Access Compliance Report

Public Rights-of-Way

(Curb Ramps)

Intersection ID: 50008	Main Street: BERKELEY_PLACE_DR	Cross Street: SALERNO_DR	Location: E
ADA ID: EA89E0B437BD	Ramp Type: PerpDiag	Initial Pass/Fail: Fail	Overall Compliance: No
Severity Score: 13.75			
Codes/Mitigation Info/Possible Solution		Field Measurements/Component Compliance

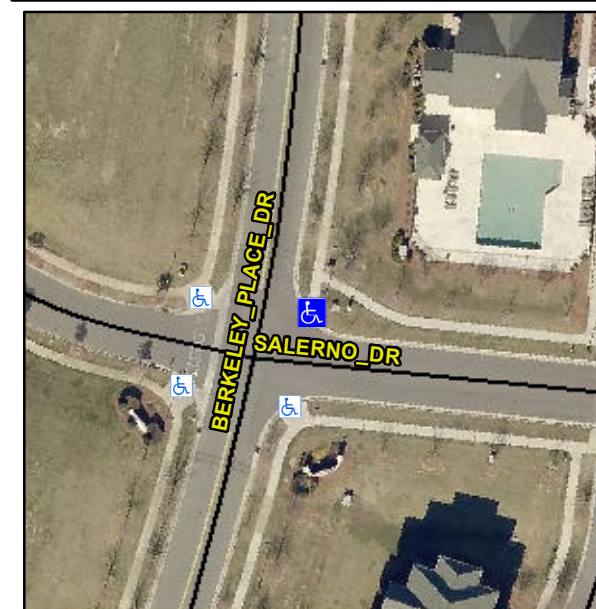
R304.2.2, R304.5.3

Compliance	Description	Data	Compliance	Description	Data
N/A	Ramp Length (in)	55.0	No	Ramp Slope (%)	10.0
Yes	Ramp Width (in)	48.0	No	Ramp XSlope (%)	4.9
N/A	Flare Type LT	N/A	N/A	Flare Type RT	N/A
N/A	Flare Slope LT (%)	N/A	N/A	Flare Slope RT (%)	N/A
N/A	Flare Traversable LT?	N/A	N/A	Flare Traversable RT?	N/A
N/A	Landing Length (in)	N/A	N/A	DWS Provided?	N/A
N/A	Landing Width (in)	N/A	N/A	DWS Contrast?	N/A
N/A	Landing Slope (%)	N/A	N/A	DWS Length (in)	N/A
N/A	Landing X Slope (%)	N/A	N/A	DWS Full Width?	N/A
N/A	Landing Curb? (Y/N)	N/A	N/A	DWS Offset (in)	N/A
N/A	Shared Landing?	N/A			
N/A	Gutter Ponding?	N/A	N/A	Gutter Slope (%)	N/A
N/A	Gutter Lip Ht (in)	N/A	N/A	Gutter X Slope (%)	N/A
N/A	Painted X Walk1?	No	N/A	Painted X Walk2?	No
	X Walk 1 Direction	To NW		X Walk 2 Direction	To SW
N/A	X Walk 1 Width (in)	N/A	N/A	X Walk 2 Width (in)	N/A
	X Walk 1 Slope (%)	7.1		X Walk 2 Slope (%)	4.0
	X Walk 1 X Slope (%)	2.3		X Walk 2 X Slope (%)	6.9

Remove & Replace Curb Ramp With Two New Directional Ramps or Equivalent.
